5 EAST MELROSE STREET, CHEM CHASE  
[HPC CASE # 35/13-13 KK]  
CHEM CHASE VILLAGE H.D.

SUBJECT: Historic Area Work Permit #654911, construction of rear addition and other alterations

**PROPOSAL:** Construction of rear addition and other alterations

DRAWING TITLE  
SIDE DOOR  
PRECEDENTS AND  
PROPOSED

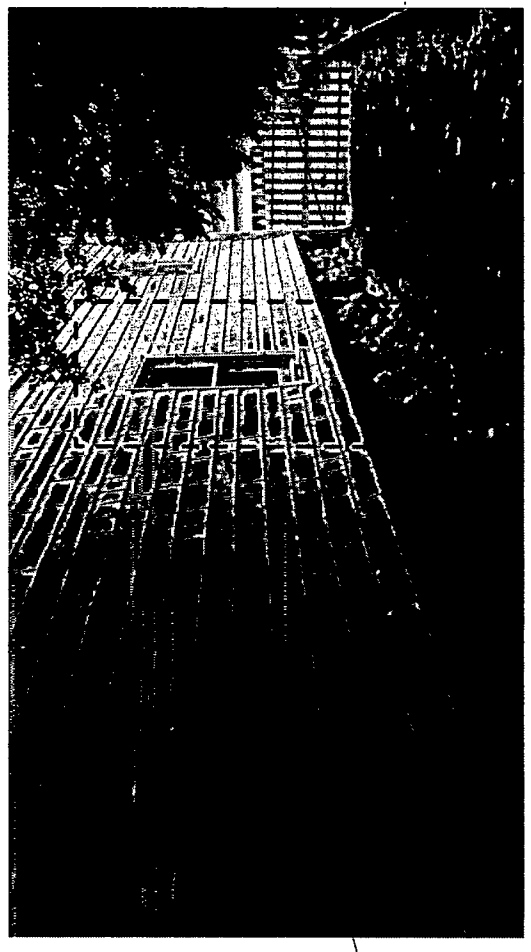
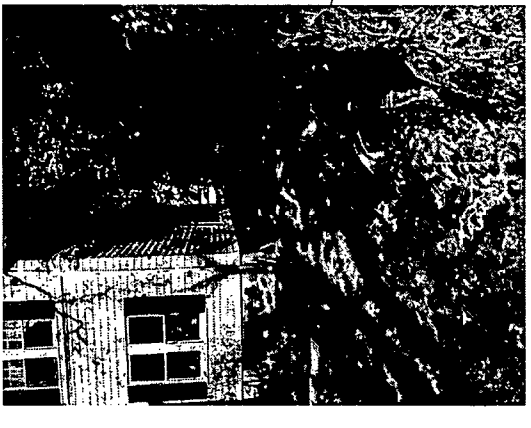
Although the removal and replacement of historic materials such as windows and doors and alteration of an original window opening is generally discouraged, staff finds the applicant's proposal to remove and replace the existing east (right) elevation window with a door and associated enlargement of the opening, as being consistent with *Guidelines*.

Applying the "Moderate Scrutiny" principle staff finds the following: the subject window location is on a secondary elevation, and just above the foundation level, and within close proximity to the adjacent property. These factors reduce visibility of the window from the public right-of-way, and therefore replacing the window with a door would have negligible impact.

The proposed wooden replacement door style and material is compatible with the structure's existing design. The removal of this non-character defining feature and installation of a new door, will result in negligible impact to the structure's architectural integrity, and therefore should be approved as submitted.

The applicant has demonstrated with photographic evidence the presence of side yard doors throughout the historic district. (See page 25 of the staff report).

**NEED 2 SECTIONS:**

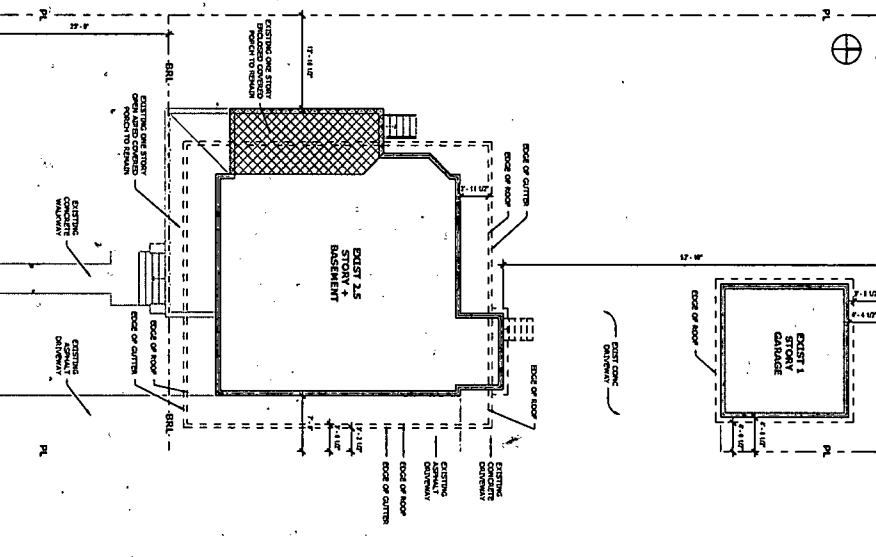
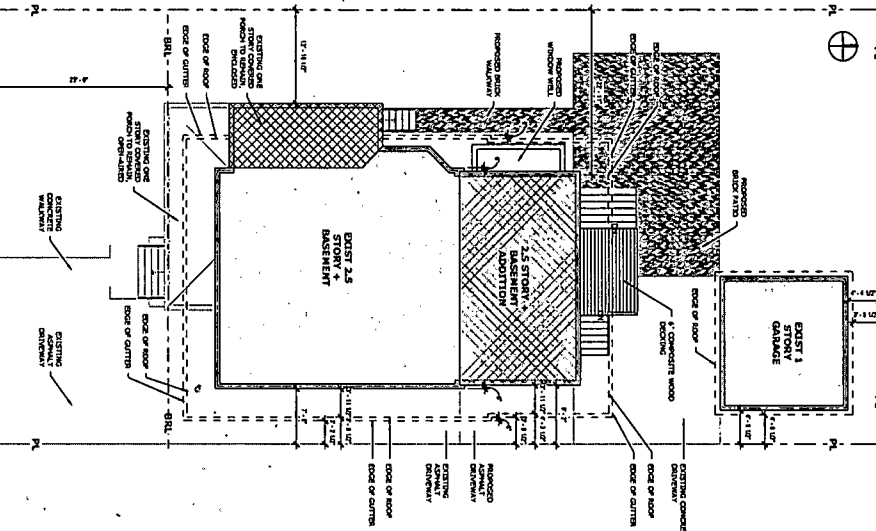
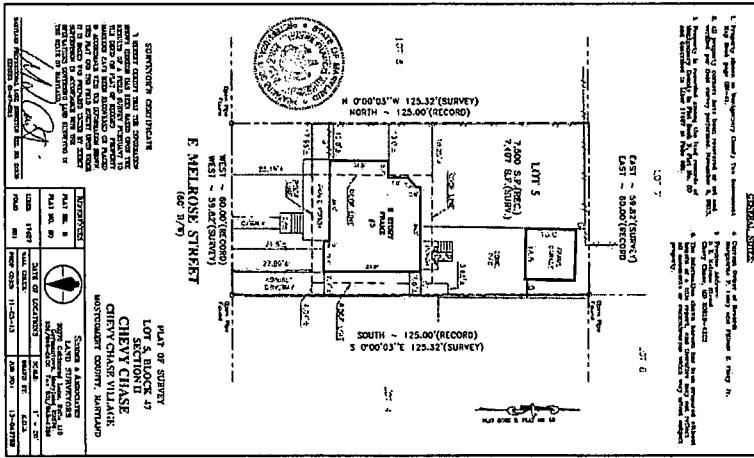
① 12" wall/roof (HPX APPROX)

② 6" " / " ADDITIONAL RESTRICTION

**PURPOSE:** TO SHOW WHAT APPLICANT WOULD LIKE IN WIDTH AND HEIGHT

DRAWING TITLE  
**EAST ELEVATION**

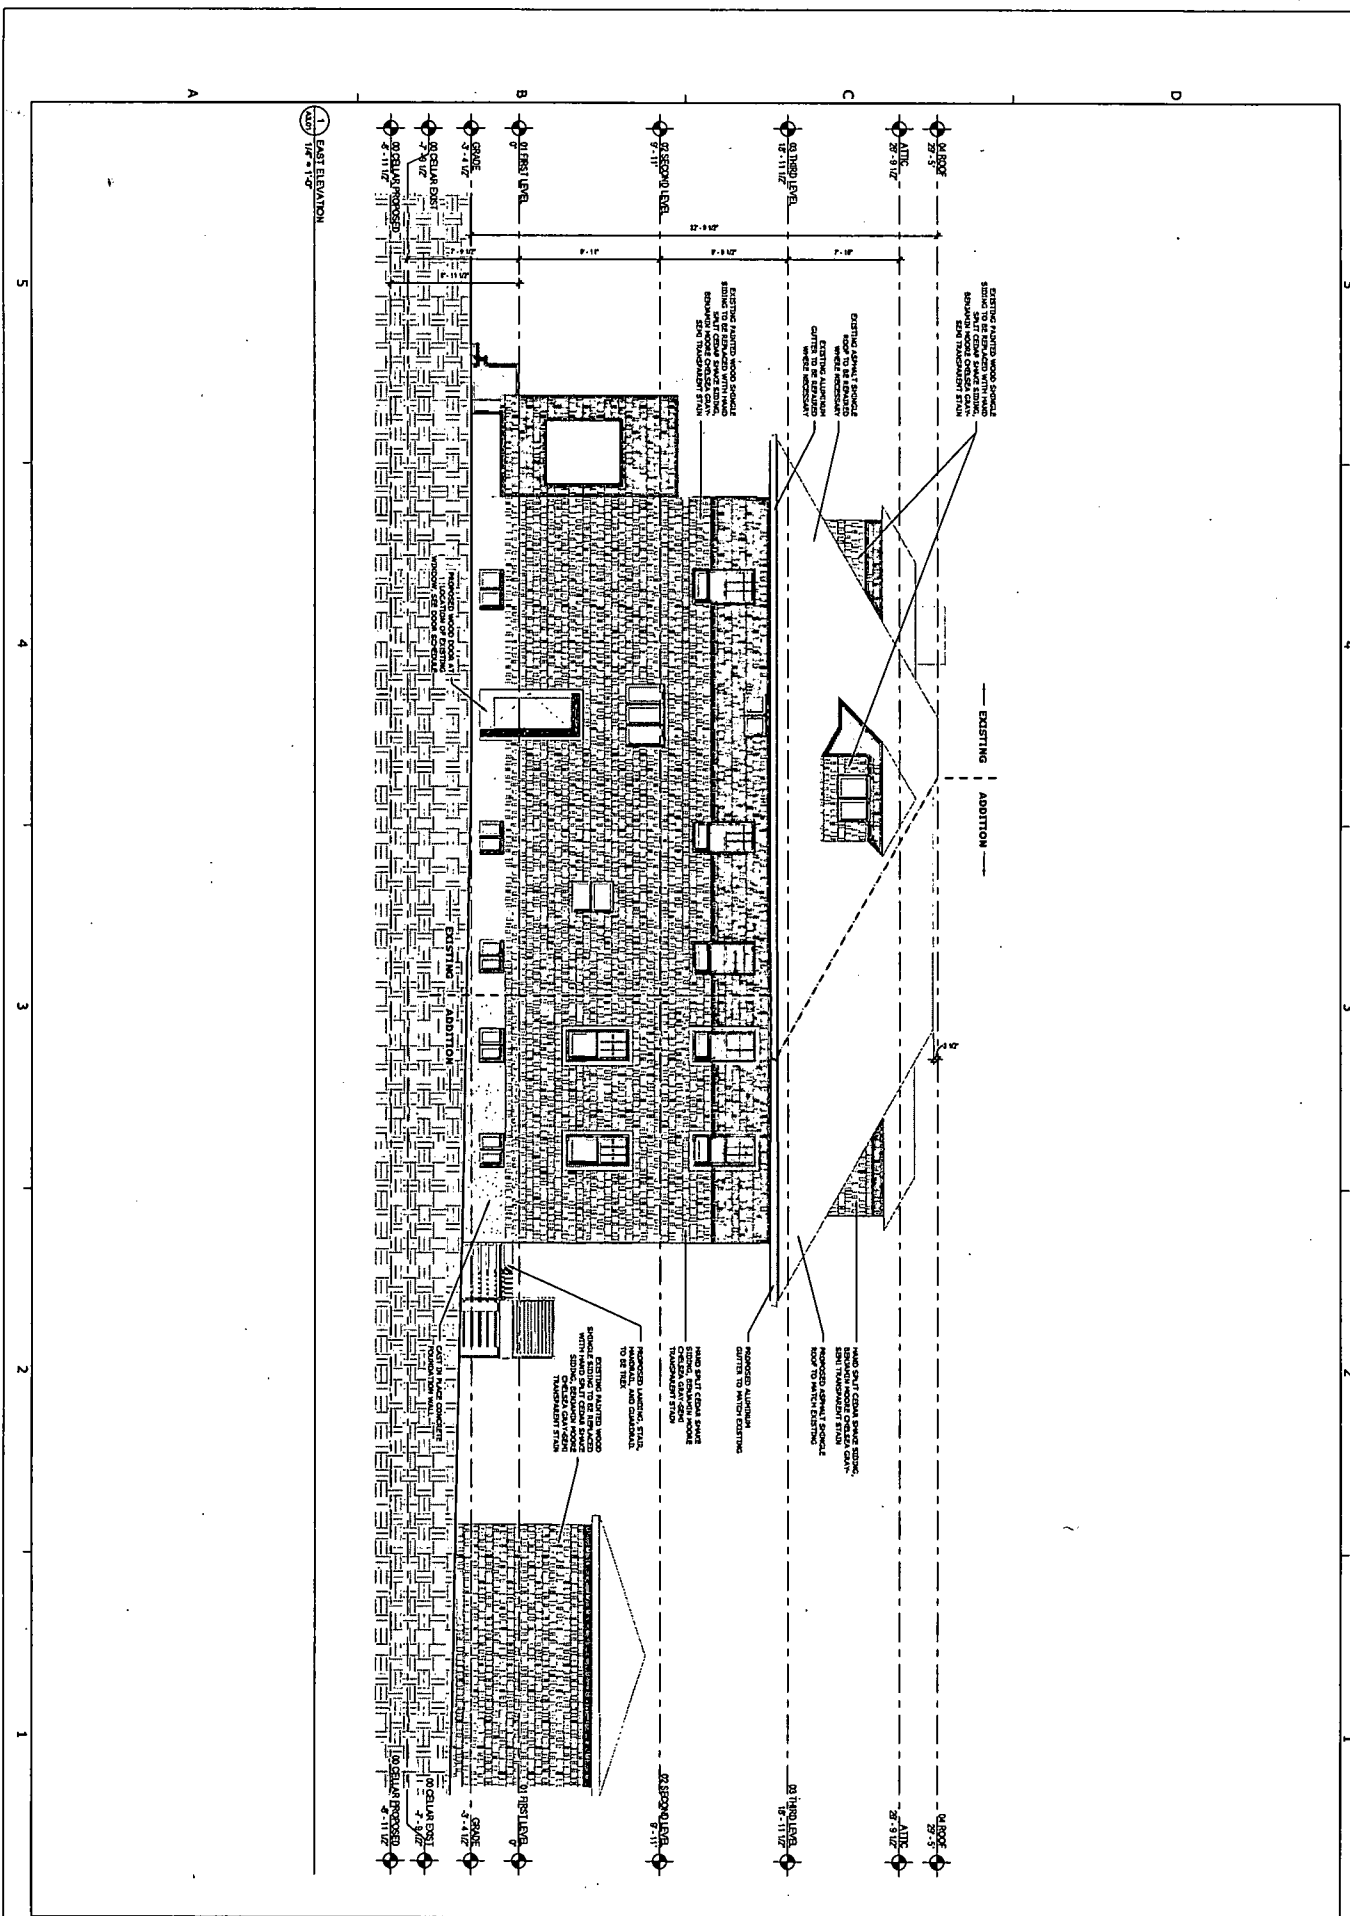
- 2. The proposed east and west elevation walls of the addition must be inset 12" where they meet the historic massing. The gutter line and soffit of the addition be maintained to match the overhang of the existing roof. Consult HPC approved building permit set of plans for final roof and wall measurements and details.*

The addition as proposed does not conform with Chevy Chase Village's side yard setback requirements. The gutter and soffit on the east (right) elevation encroaches into the side yard setback. The applicant has submitted a variance request to the Village Board. The applicant's request is scheduled for Board's consideration at their December 9, 2013 meeting. The Village Manger has reviewed the plans and indicated the applicant's request is very much in keeping with previously granted Board decisions and no major concerns in the hearing of the case are anticipated. (See page 29 of the staff packet).

As you know CCV signed off on the 6" insets, which was a very big hurdle to get through. We only designed the 12" insets because we thought we would be able to maintain the existing roofline. I know of many other historic and CCV homes that do not inset 12". I have altered my plans numerous times to everyone of your requests and I'm asking that you to accept the 6" insets.
